**ZONING AMENDMENT
& SUBDIVISION STAFF REPORT****Date: July 7, 2016****APPLICANT NAME**

Du Chien Subdivision

LOCATION4297 Riviere Du Chien Road
(Southwest corner of Riviere Du Chien Road and Halls
Mill Road, extending to the North side of I-10).**CITY COUNCIL
DISTRICT**

Subdivision approval to create a single legal lot of record from two metes-and-bounds parcels, and Zoning approval to rezone the site from R-1, Single-Family Residence District and B-3, Community Business District, to I-1, Light Industry District, to eliminate split zoning.

SITE PLAN

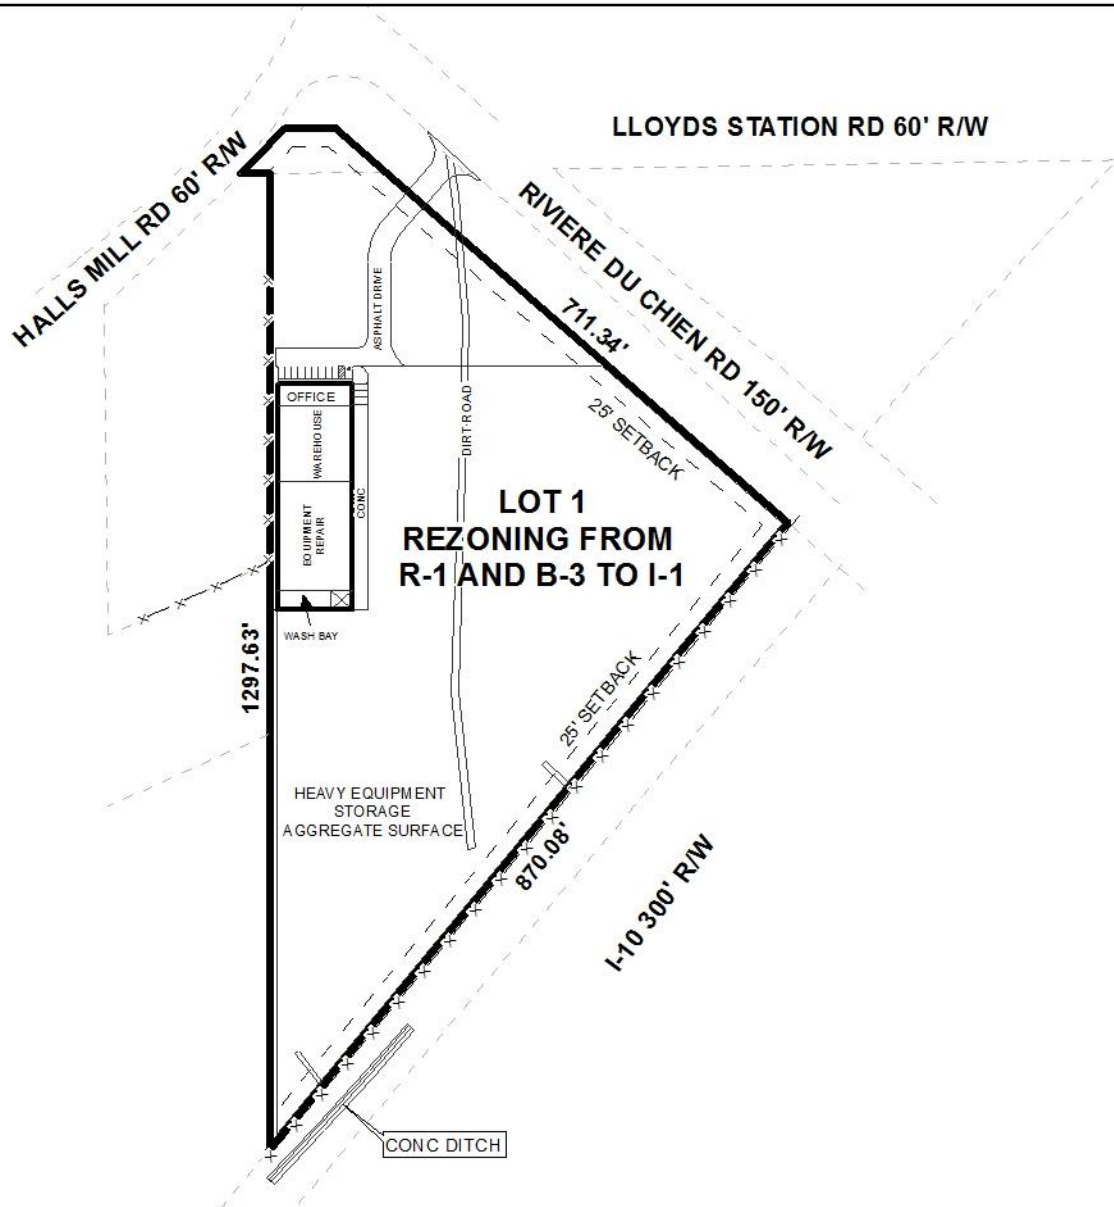
The site plan illustrates a proposed 30,000± s.f. building, 3,000± s.f. of which is dedicated for office use, and 27,000± s.f. of which is dedicated for warehousing and other industrial uses; however, the size of the proposed structure is not illustrated on the site plan which should be revised to provide this information.

At least 10 parking spaces are required given the amount of proposed office space, and 13 are provided, one of which is van accessible. Each space meets the minimum size requirements of the Zoning Ordinance regarding stall length and width, but Staff cannot verify the site will be adequately served by the appropriate number of parking spaces without knowing the proposed amount of warehouse employees; the Zoning Ordinance requires one (1) parking space per three (3) warehouse employees. As such, a revised site plan indicating the proposed number of warehouse employees, and any revisions to the required number of parking spaces as a result of such provisions, will be required for permitting, if approved.

It should be noted that it is unclear whether or not the aforementioned parking spaces will be provided with curbing or wheel stops where vehicles may potentially extend beyond the parking area. It is also unclear how at least three parking spaces along the eastern portion of the proposed building will be accessible considering the site plan seems to illustrate that asphalt paving is only provided for the proposed parking spaces along the northern portion of the proposed building. It seems that the extension of vehicles beyond the parking area will be mitigated by curbing, and that access to the aforementioned, proposed three parking spaces will be facilitated by either a portion of a proposed concrete apron, and/or aggregate surfacing; however, it should be noted

that all required parking must be paved. If approved, a revised site plan clarifying this information will be required for permitting.

Tree and landscape area information is not provided on the site plan. I-1, Light Industry Districts are not exempt from landscaping requirements of the Zoning Ordinance, and frontage trees are also required; these details are contained within Section 64-4.E.3. of the Ordinance, and should be depicted on a revised site plan.

A dumpster is not depicted on the site plan, and no note discussing waste removal from the site is provided. Any dumpster placed on the property must be in compliance with the current enclosure and sanitary sewer connection requirements of Section 64-4.D.9. of the Zoning Ordinance, and must be illustrated on any revised site plan(s); or, placement of a note on the site plan stating that curbside pickup will be utilized is acceptable, if approved.
